FIELD MODIFICATION FORM  
FOR  
CORNELL DUBILIER ELECTRONICS SUPERFUND SITE: OU4 BOUND BROOK  
THE LOUIS BERGER GROUP, INC.

**DATE:** May 15, 2013

**DOCUMENT:** Quality Assurance Project Plan  
Cornell Dubilier Electronics Superfund Site: OU4 Bound Brook

**ACTIVITY:** Field Modification No. 9  
Veterans Memorial Park – Floodplain Soil Investigation

2013  
Figure 1

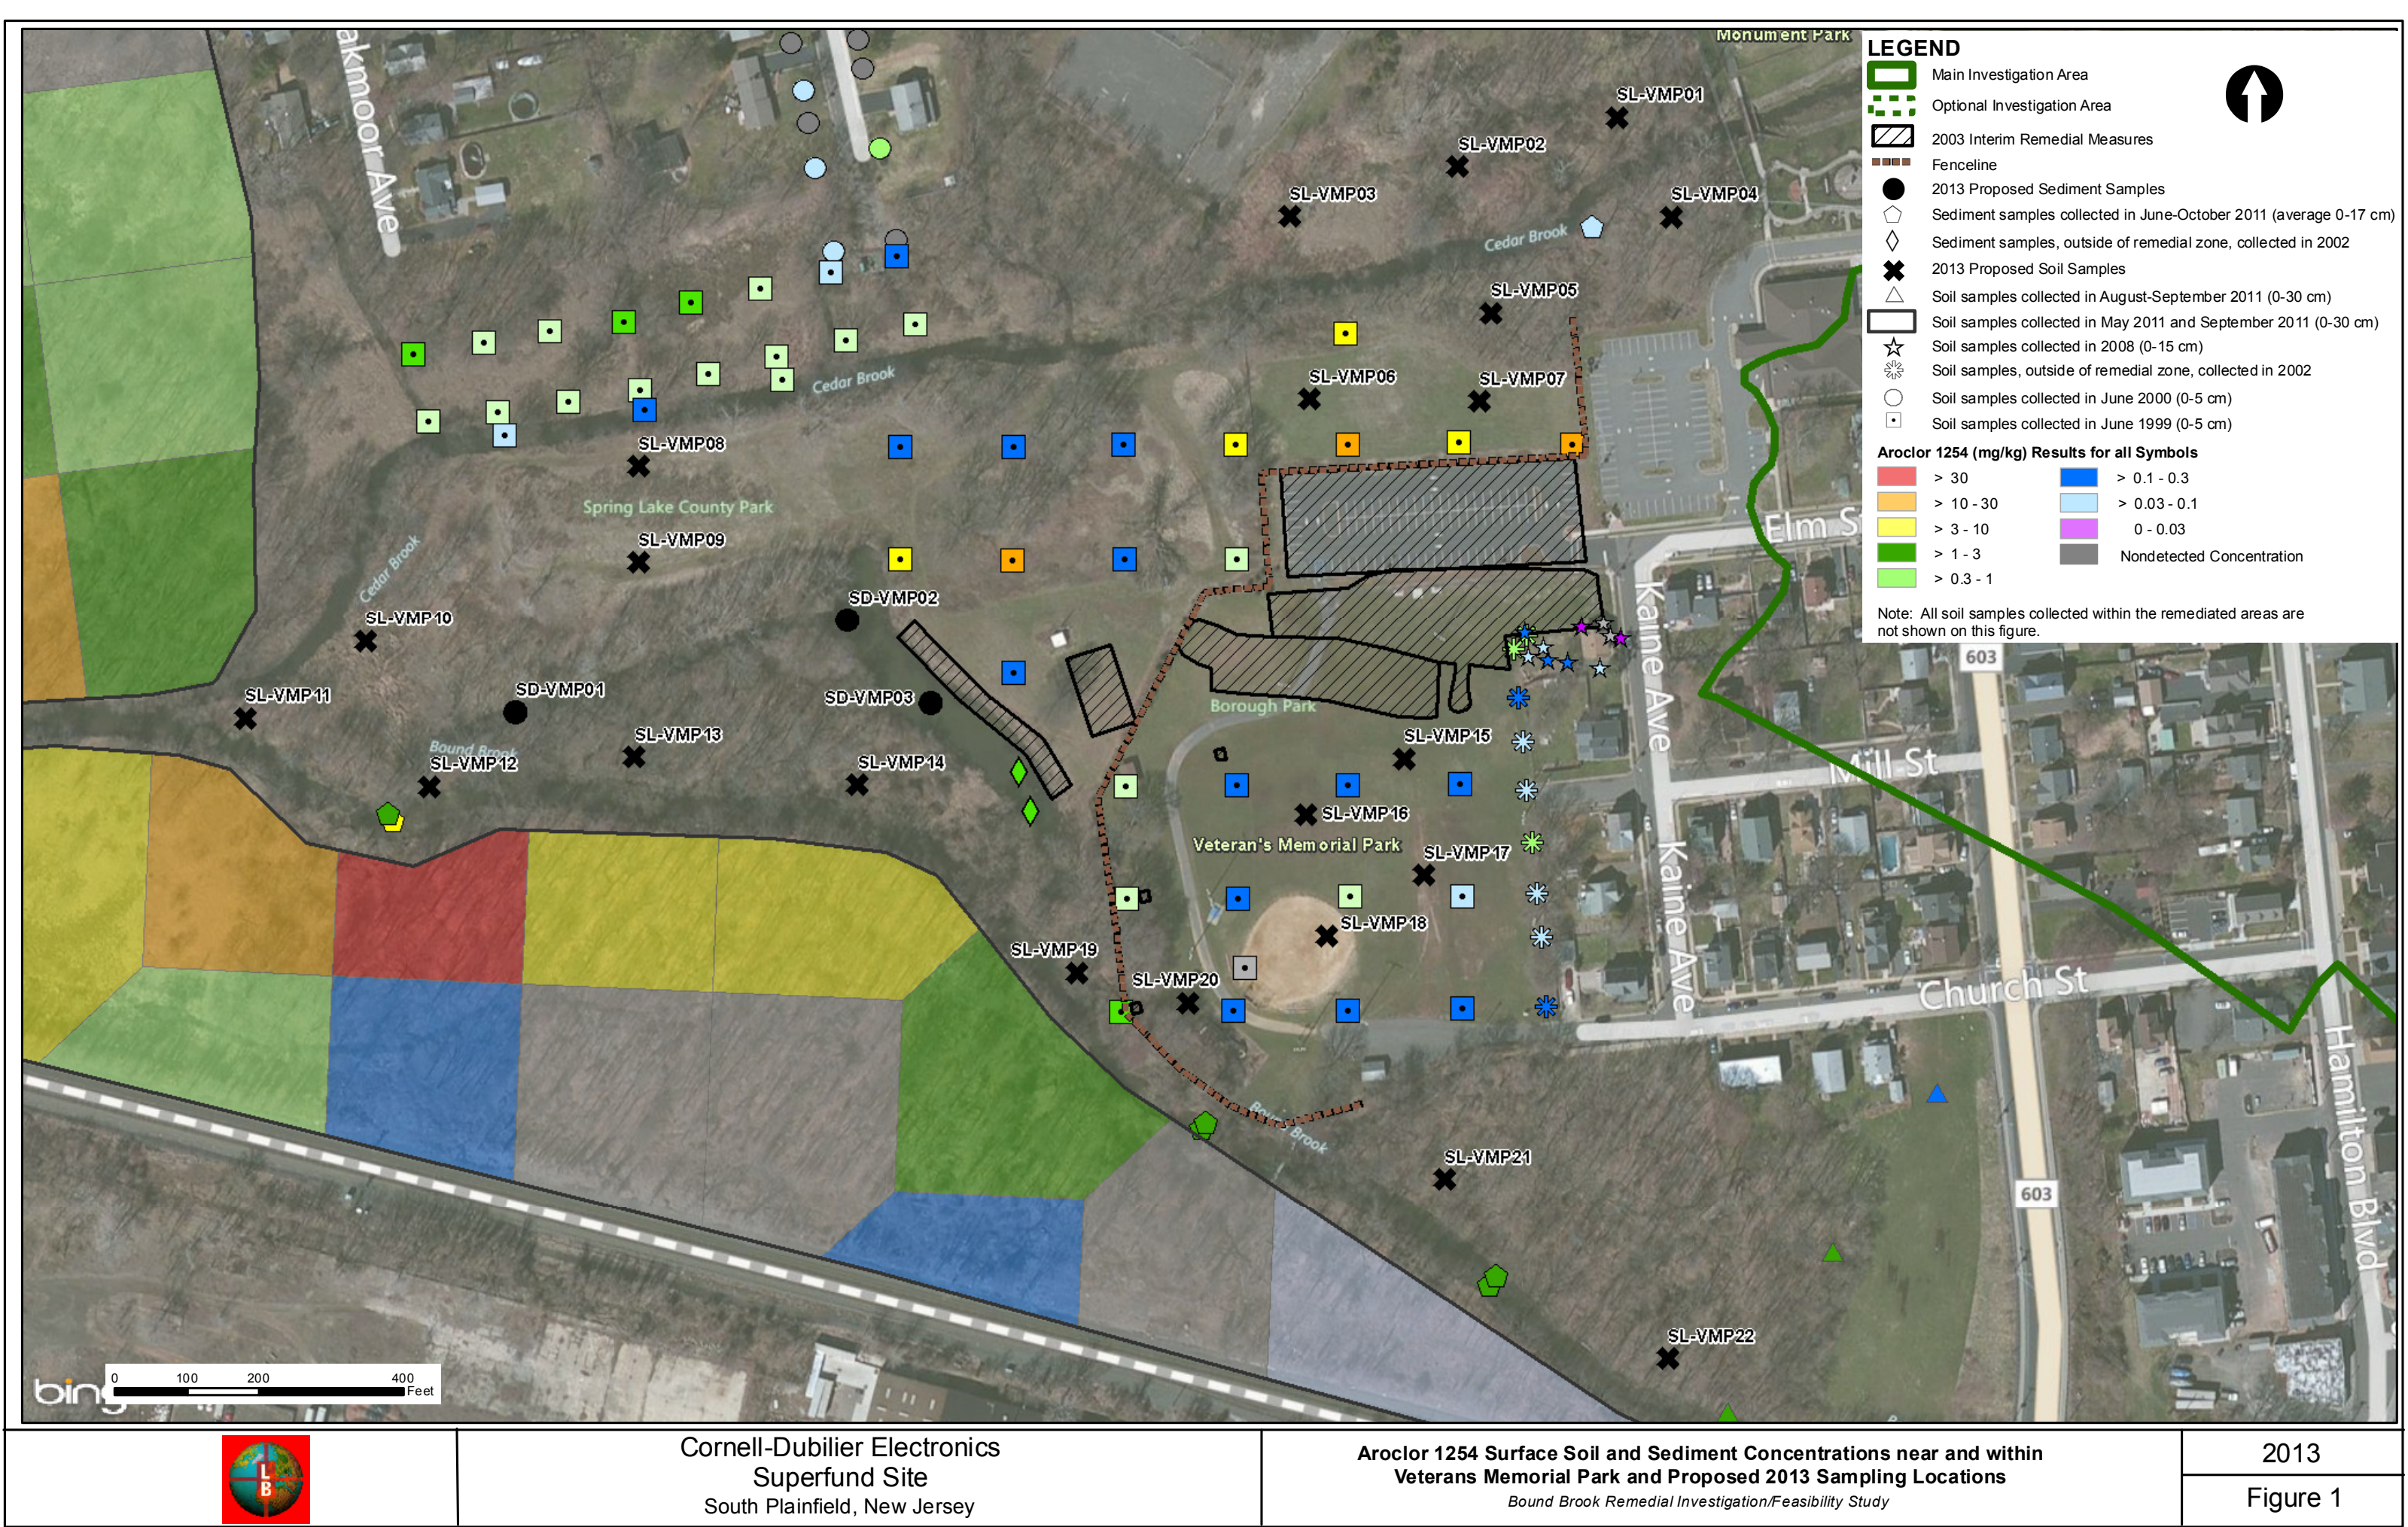
Field Modification No. 9 provides for the collection of 22 floodplain surface soil samples and 3 surface sediment (from a ponded area) samples to characterize the current polychlorinated biphenyl (PCB) Aroclor concentrations in Veterans Memorial Park and surrounding open "green" space on the floodplain to support the risk assessment. As part of the RI, floodplain surface soils were collected to assess potential exposure to residents recreating in the floodplains. Due to flooding of Bound Brook and transport of contaminated sediments onto the floodplains, USEPA requested that additional floodplain surface soils be collected in Veterans Memorial Park (South Plainfield, New Jersey) and the surrounding open "green" space on the floodplains located between Cedar Brook and Bound Brook. Soil and sediment samples collected from Veterans Memorial Park will be incorporated into the existing OU4 RI database. Together, these data will be used to evaluate nature and extent of contamination on the floodplains (which will be discussed in the OU4 RI); evaluate potential remedial alternatives for the floodplains (which will be discussed in the OU4 FS); and identify migration pathways, potential receptors, and potential human and ecological health risks in the floodplains (which will be discussed in the OU4 risk assessment).

USEPA requested that additional floodplain surface soils be collected in Veterans Memorial Park and the surrounding open "green" space on the floodplains located between Cedar Brook and Bound Brook.

<b>Sampling Location/ID Number</b>	<b>Matrix</b>	<b>Estimated Penetration Depth</b>	<b>Analytical Group</b>	<b>Conc Level</b>	<b>Number of Field Samples</b>	<b>Sampling SOP Reference</b>	<b>Rationale of Sampling Location</b>
SD-VMP01 though SD-VMP03	Sediment	0-15 cm	PCB Aroclor	Low	1 sample per location (total of 3 sediment)	SOP No. 21	Assess potential exposure to residents recreating in Veterans Memorial Park and surrounding open “green” space on the floodplain as well as potential exposure to residents recreating in ponded area near Veterans Memorial Park. Sampling locations were selected following site reconnaissance (dated March 27, 2013), which documented evidence of human use in floodplain area and around the pond, review of existing floodplain soil and sediment data, and review of interim remedial measures implemented at Veterans Memorial Park by the Borough of South Plainfield.
SL-VMP01 though SL-VMP22	Soil	0-15 cm	PCB Aroclor	Low	1 sample per location (total of 22 soil)	SOP No. 22

Refer to attached figure for proposed sampling locations.
